Agenda Item #1

Application 2024-13-CA

30 Hannon Avenue

After-the-Fact Approval: Reframe rear addition, fenestration changes, and install drop siding.

Site Photos – 30 Hannon Avenue

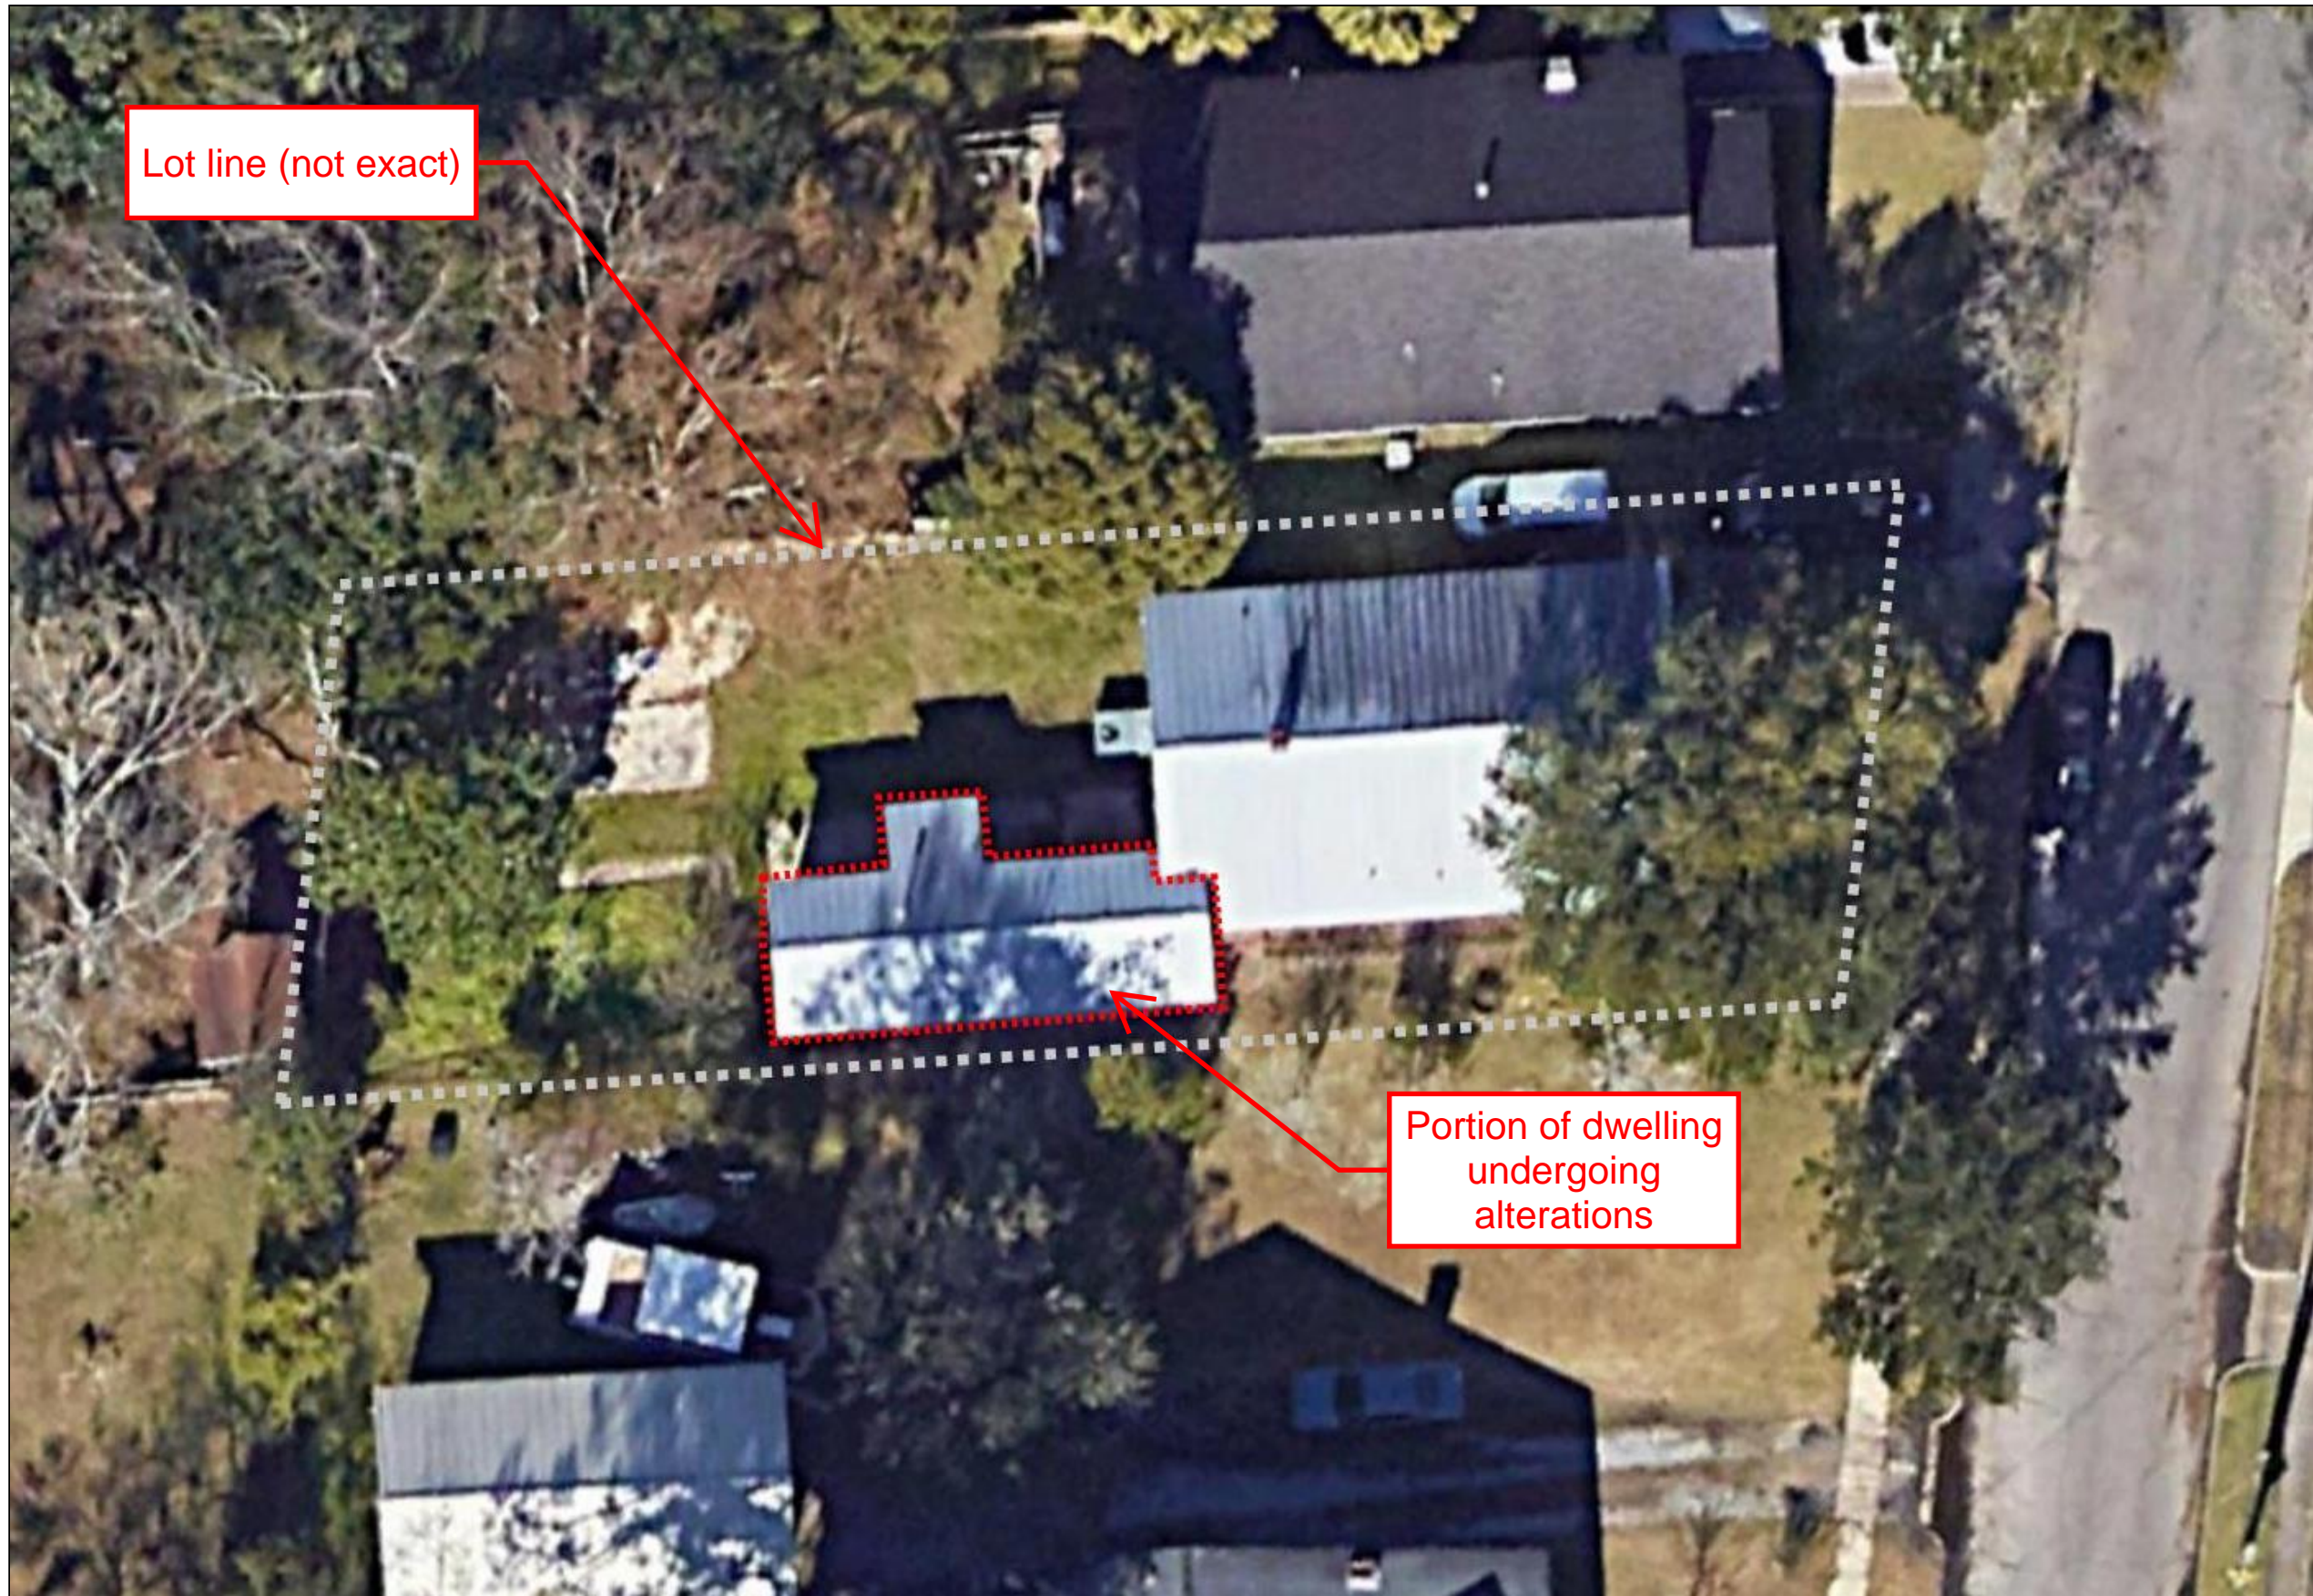
According to the *Guidelines*, replacement doors should align with the historic character of the building. Although a divided light or panel door would arguably be a more appropriate style, the single light replacement door on the east elevation of the addition (see Photo 3) is not located on a primary façade and somewhat echoes the prairie style divided light entry door on the main façade. However, vinyl is not listed as an acceptable material for historic buildings. Further, the sliding glass door on the north elevation is not compatible with the historic character of the property or district. (5.15)

The *Guidelines* state that intact historic windows should be retained and repaired, preserving elements such as light configuration, frames, sashes, muntins, etc. In cases where windows are not repairable, new windows should match the existing as per location, framing, and light configuration. Due to the fenestration changes having been completed prior to obtaining a COA, no window survey was completed. According to the applicant, the original windows are no longer extant. Therefore, their condition at the time of removal is unknown. The replacement windows do not comply with the *Guidelines'* directive to match the existing location, framing, and light configuration of the original windows. The removal of all windows on the south elevation, leaving a blank side

wall with one small, high-wall window in the east corner is not an appropriate alteration. The removal of a traditional fenestration pattern and the established solid-to-void ratio creates an unsuitable contemporary expression on a historic elevation. Likewise, the north elevation, though less visible from the street, has been inappropriately rehabilitated using a contemporary fenestration arrangement such as the pairing of narrow one-over-one windows and the installation of a horizontal sliding glass door. In addition, vinyl is not an approved material for Mobile's historic districts. (5.20-5.22)

RIGHT SIDE EXTERIOR ELEVATION

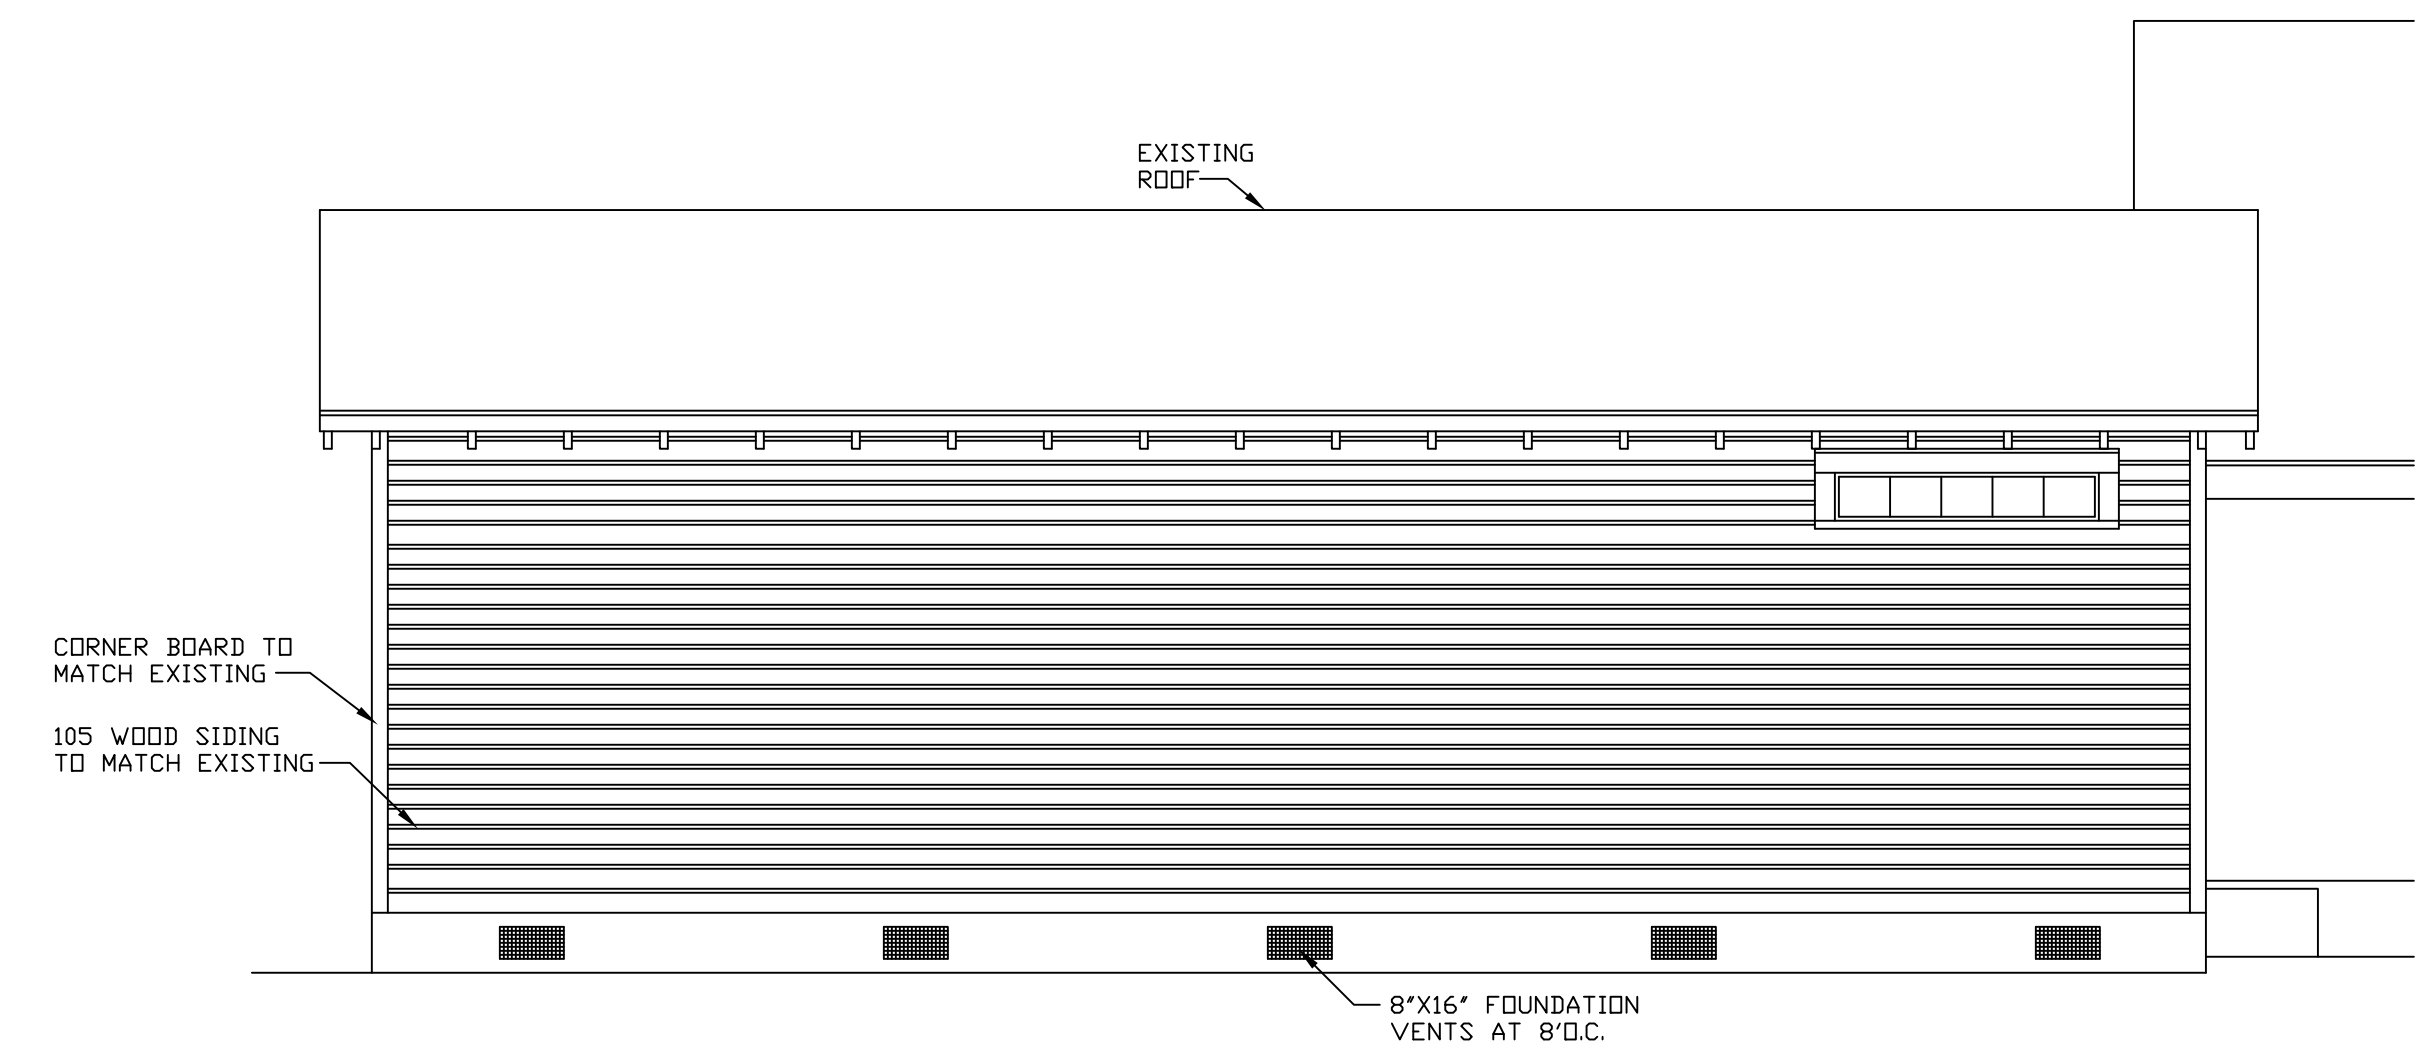
- a. Remove all windows on the south elevation (five windows) and replace with one four-light transom wood window measuring 40” wide by 12” high, located on the east end of the elevation.
- b. Prior to removal, the fenestration on the south elevation was as follows (from east to west):
Small six-over-one window, a pair of six-over-one windows, a pair of six-over-one windows.

LEFT SIDE EXTERIOR ELEVATION

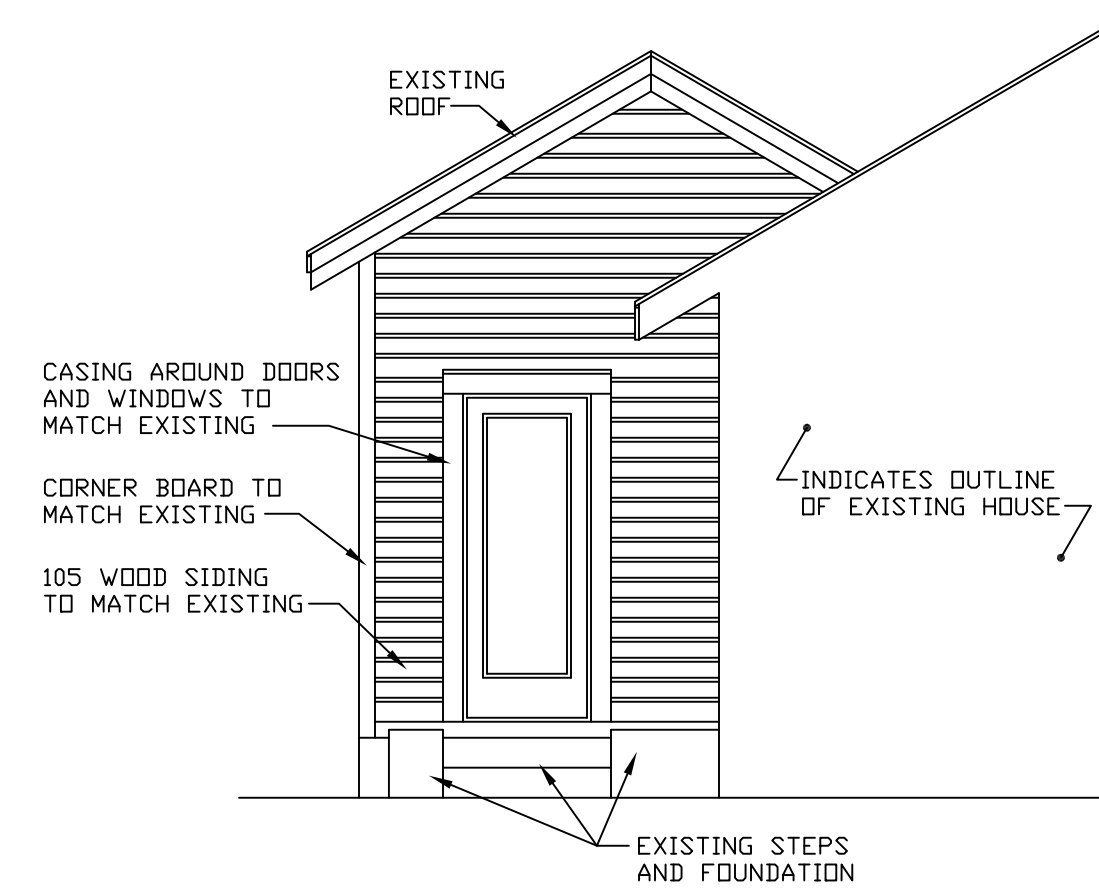
- a. Remove all fenestration on north elevation and replace with new vinyl fenestration.
- b. The fenestration pattern on the north elevation that existed prior to the alterations under review is unknown.
- c. The current fenestration is as follows:
One 1’-6” wide by 5’-0” high one-over-one window; one 1’-6” wide by 5’-0” high one-over-one window; one 2’-0” wide by 3’-0” high one-over-one window; one 6’-0” high sliding glass door.
